| Procedure: TAKEOFF MINIMUMS AND OBSTACLE DP AMDT 2 | | Enroute: NO | Specialist: Juoni, Joshua | | Agreement Number: |
| Airport ID: KFMZ | | | Airport City: FAIRMONT | | State: NE |

| FIPC BASIC FORM | | | | | | |
|--|---|----------------------------------|--|---|---|--|
| PROCEDURE: TAKEOFF MINIMUMS AND OBSTACLE DP AMDT 2 | | | AIRPORT NAME: FAIRMONT STATE | | AIRPORT ID: KFMZ | SPECIAL CONTROL NO: BP-04-208-24 |

AIRPORT ID: KFMZ
AIRPORT NAME: FAIRMONT STATE AIRFIELD
CITY/STATE: FAIRMONT/NEBRASKA
PROC ID: TAKEOFF MINS, ODP
AMDT: 2
SCALE: 1:100,000
RWY 17

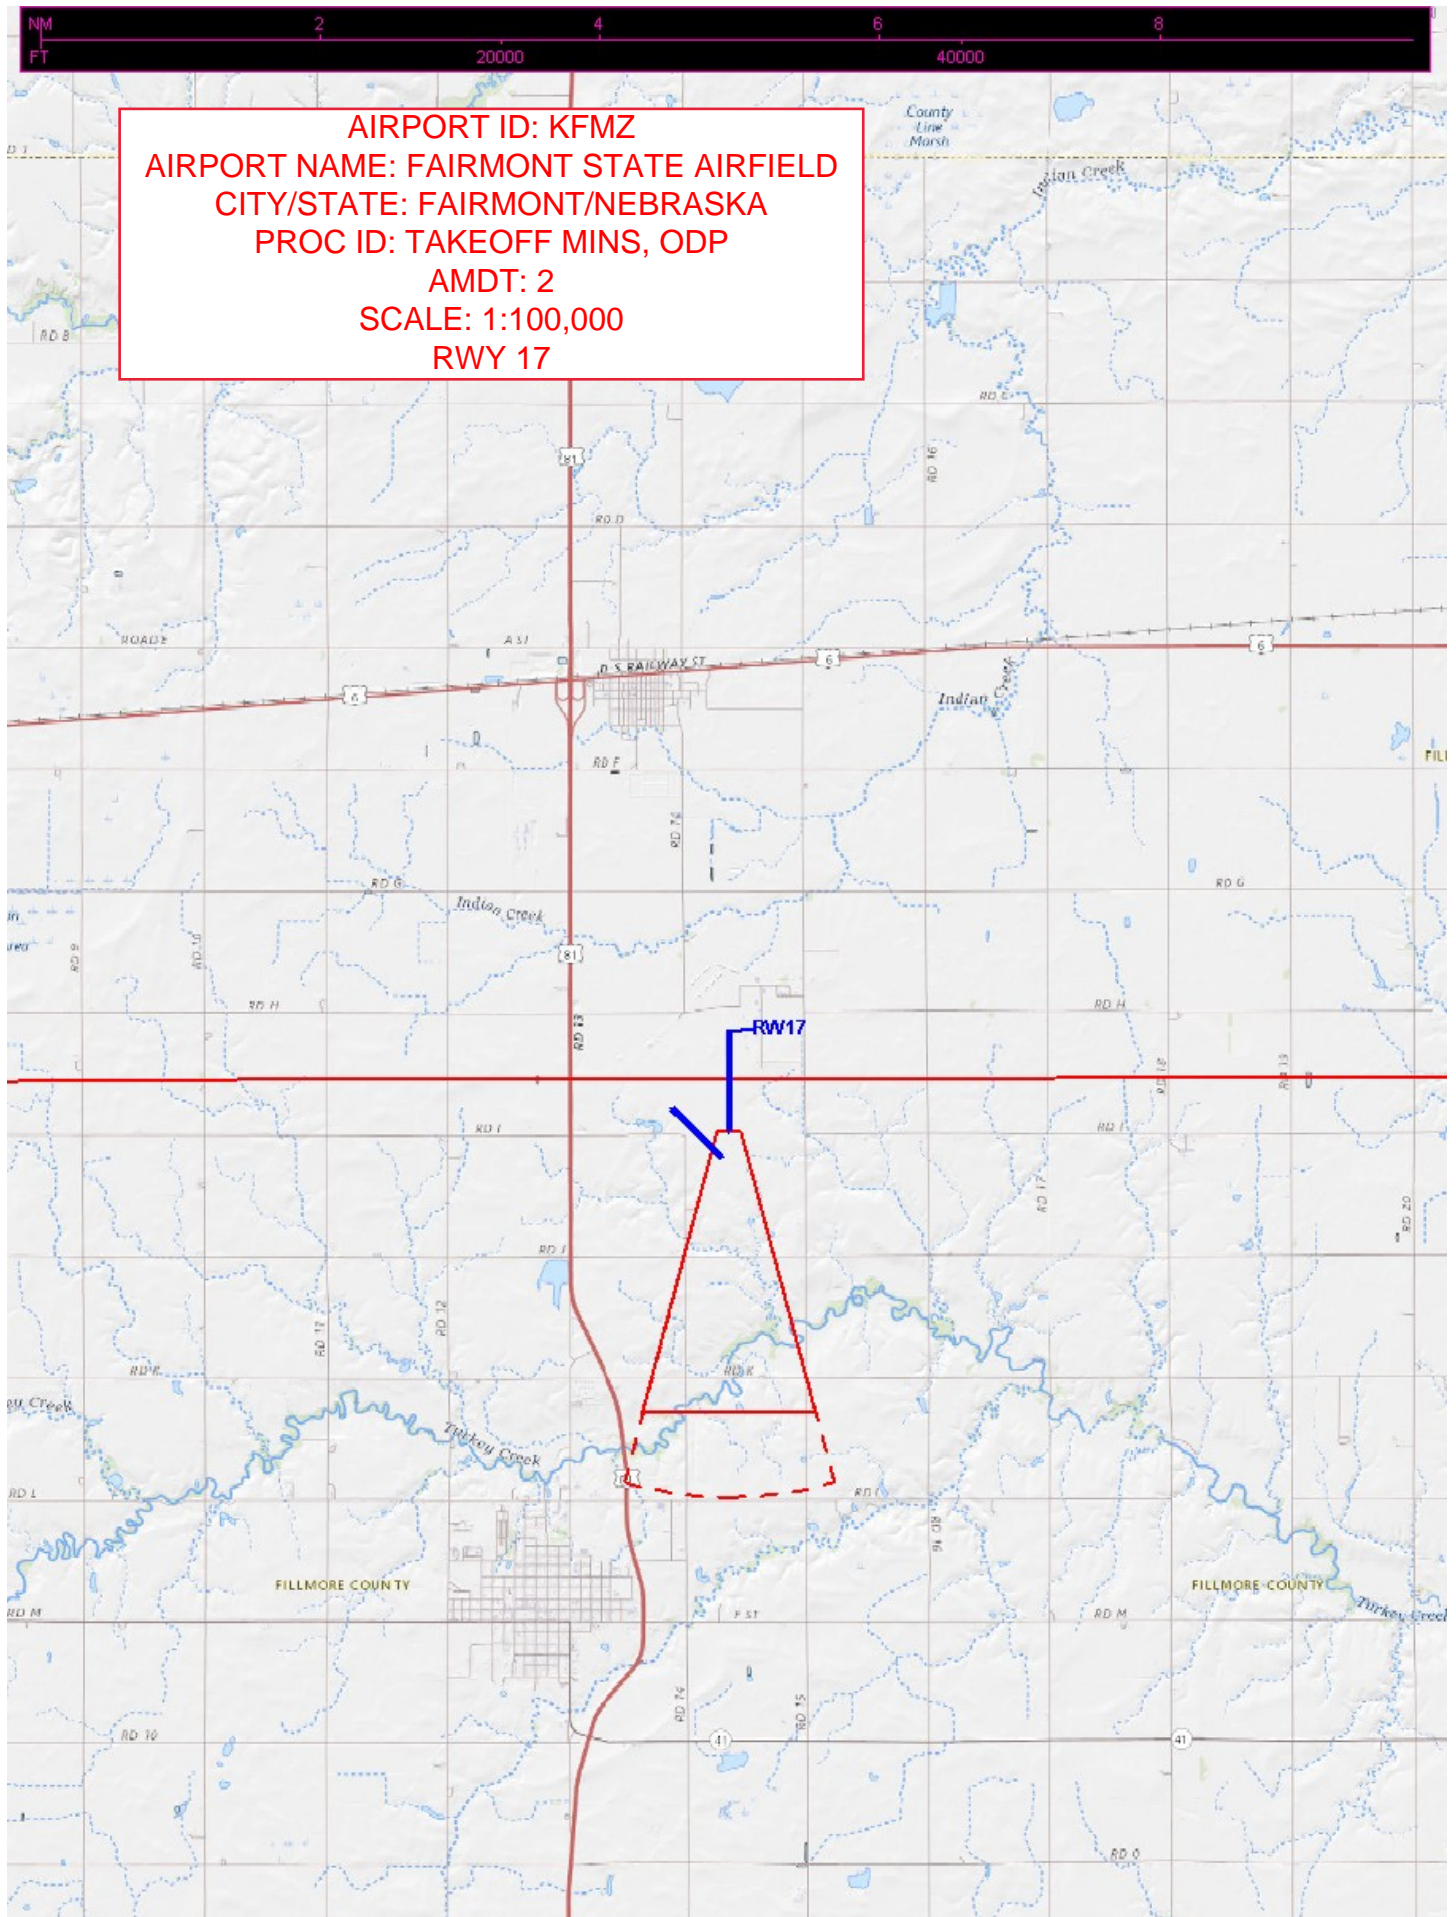
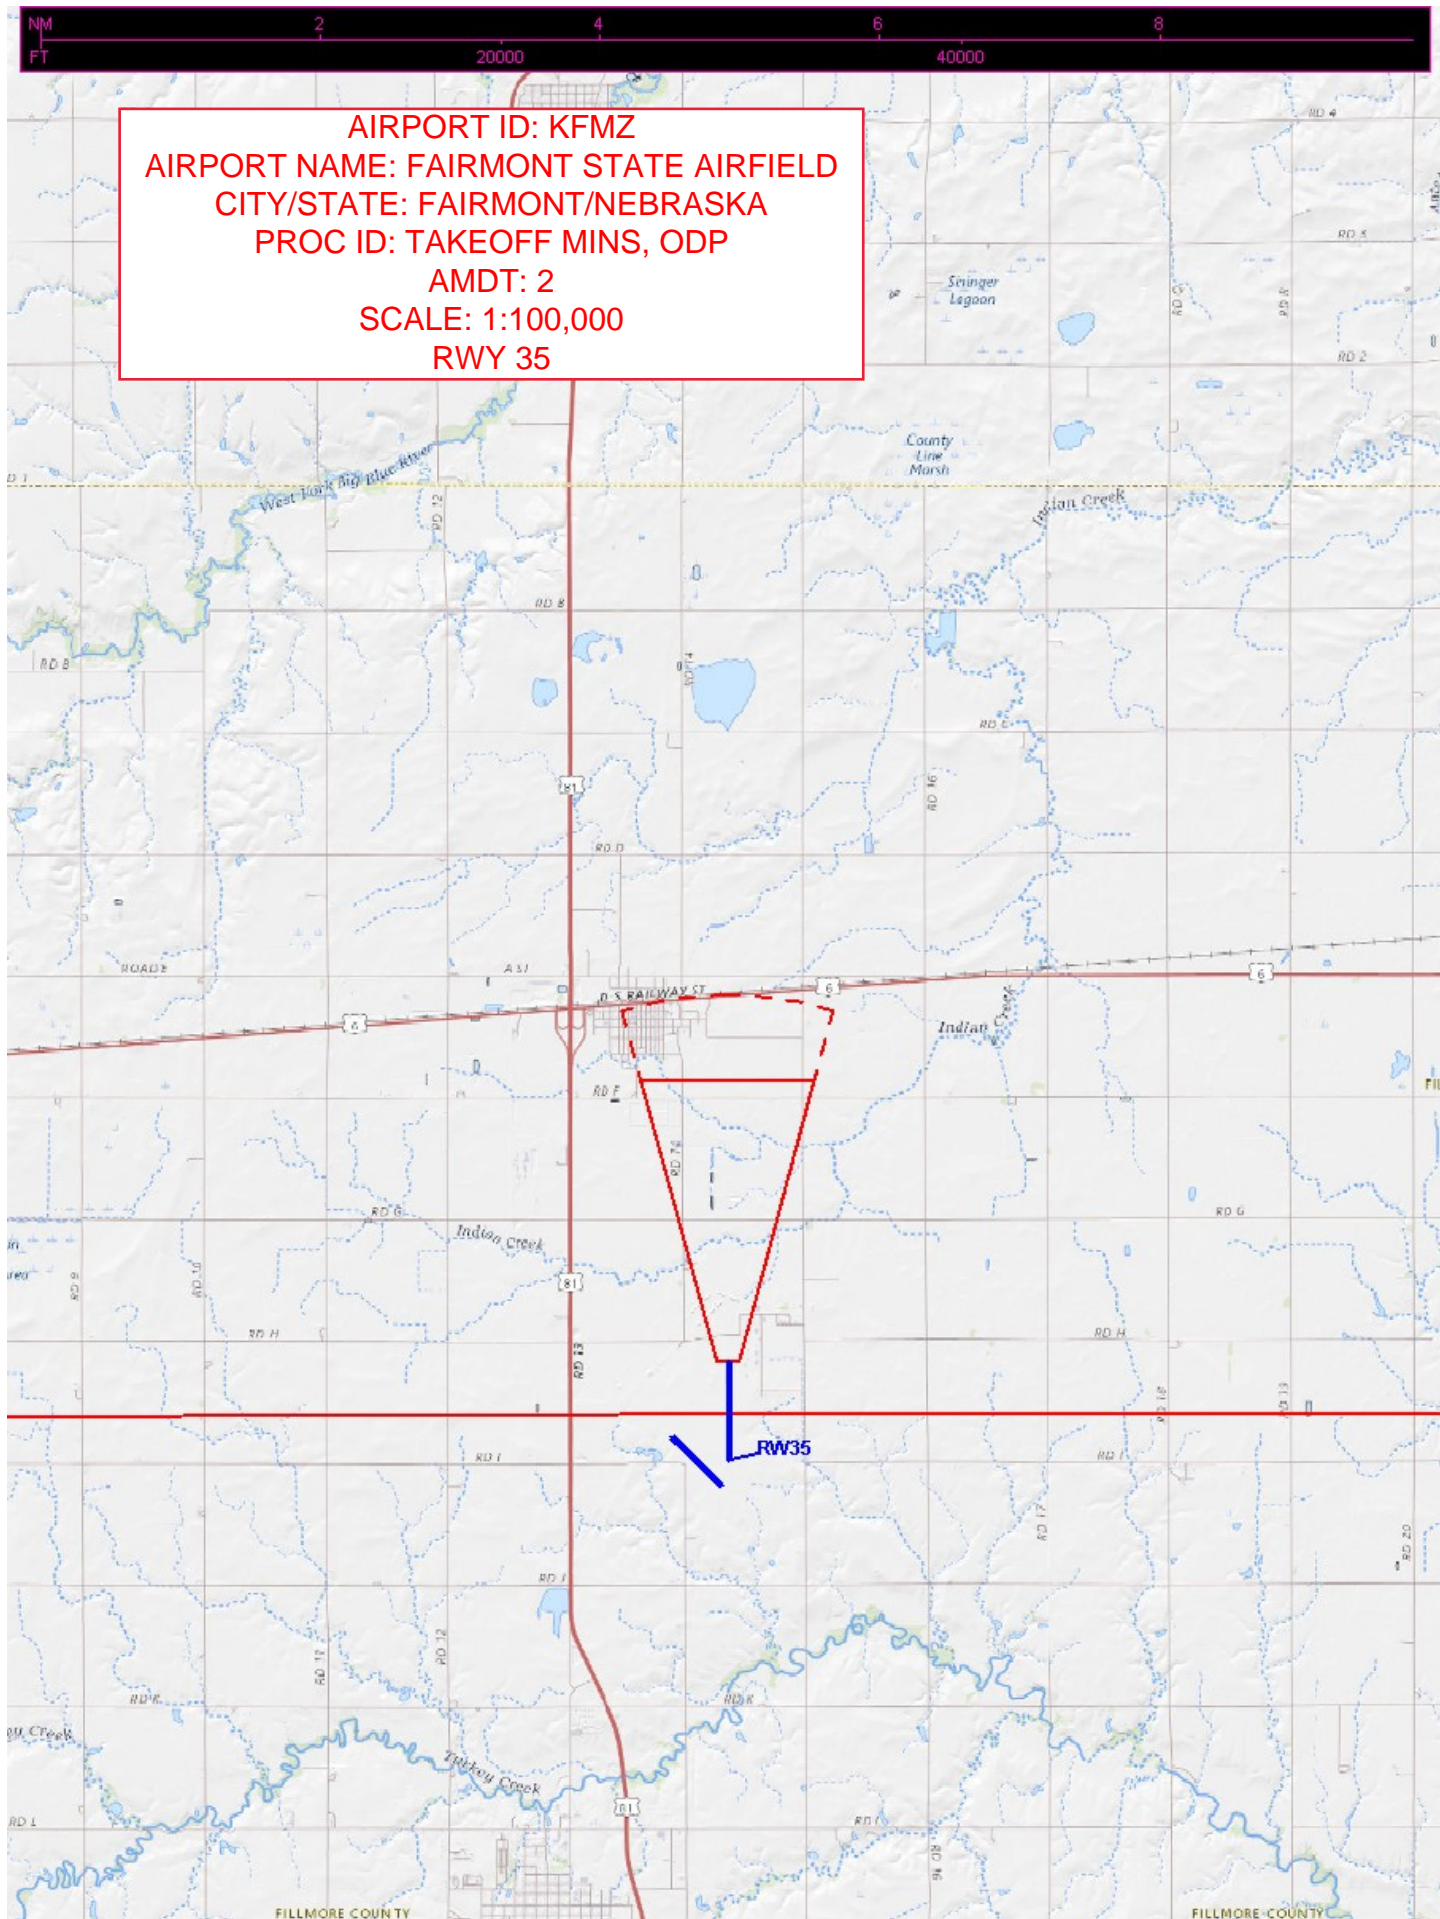
| FIPC BASIC FORM | | | | | | |
|--|---|----------------------------------|--|---|---|--|
| FLIGHT INSPECTOR REMARKS: Recommenf that a note be added for minimum climb of 500 fpm or greater required for runway 30 and 35 due to the close proximty of the the three windills to the North. | | | | | | |
